Carolina Power & Light Company

BRUNSWICK STEAM ELECTRIC PLANT, UNIT NOS. 1 AND 2
DOCKET NOS. 50-325 & 50-324/LICENSE NOS. DPR-71 & DPR-62
SHORT-TERM STRUCTURAL INTEGRITY ITEMS

BRUNSWICK STEAM ELECTRIC PLANT, UNITS 1 AND 2
NRC DOCKET NOS. 50-325 & 50-324
OPERATING LICENSE NOS. DPR-71 & DPR-02
SHORT TERM STRUCTURAL INTEGRITY ITEMS

JUSTIFICATION OF SHORT TERM QUALIFICATION
OF MAIN STEAM LINE RADIATION MONITOR SUPPORTS

SUPPORT NO. PS-1726
 CALC. NO. 8457-0003

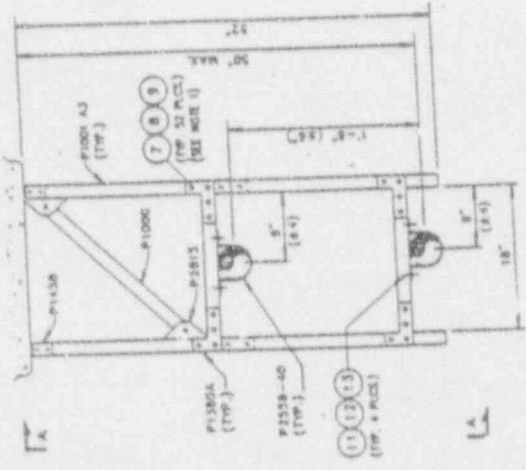
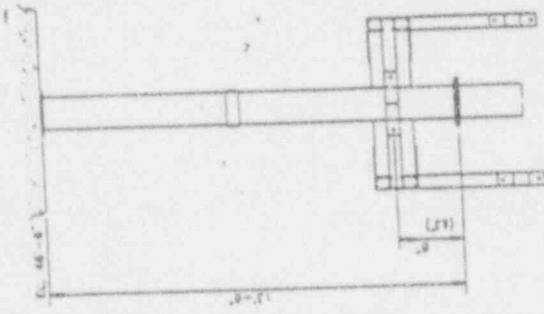
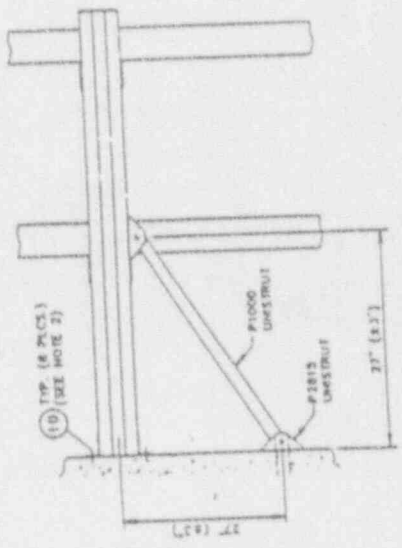
- The bolts are modeled as rigid elements indicating they are in a tightened condition. As noted under "Field Conditions", the existing bolts are loose.
- The top flange is modeled as if it were in close contact with the concrete underside of the shield plugs. The model shows restraint points in the +Y direction at nodes 36 and 37. The actual configuration in the field has a slight gap between the flange and the concrete.
- The length of element 30 should be greater than 1/2" to include the width of the gap.

- The modeling of the flange stops at the centerline of the bolts. The entire flange should be modeled, including the section outside the bolts. The flange thickness of 3/8" is not necessarily thick enough to allow rigid plate behavior, and the potential exists that prying action could increase the bolt loads. The full width of the flange should be modeled.

- The effective throat of the weld at the top flange was modeled as .12 inches on page 3 of the EZHANG input file. The actual effective throat should be $.707 \times .125$ inches = .088 inches. This will increase the stress on the weld considerably. This increase could possibly be offset by increased allowable weld stress (see Material Strength Assumptions).
- The weld of the 3/8" S.S. flange to the pipe is not specified in the model.
- The EZHANG output file in attachment C is not signed off as checked.

Based on field inspection, the STSI calculation does not represent the existing field conditions. The calculation was performed assuming A193 Gr.B7 bolts. The actual bolt material currently in the field is not known. The calculation models the bolts as being tight, although the actual configuration found in Unit 2 includes loose or bottomed-out bolts. The loose bolts could cause excessive deflection of the detector well, and the bolts will be subjected to potential non-linear impact loads.
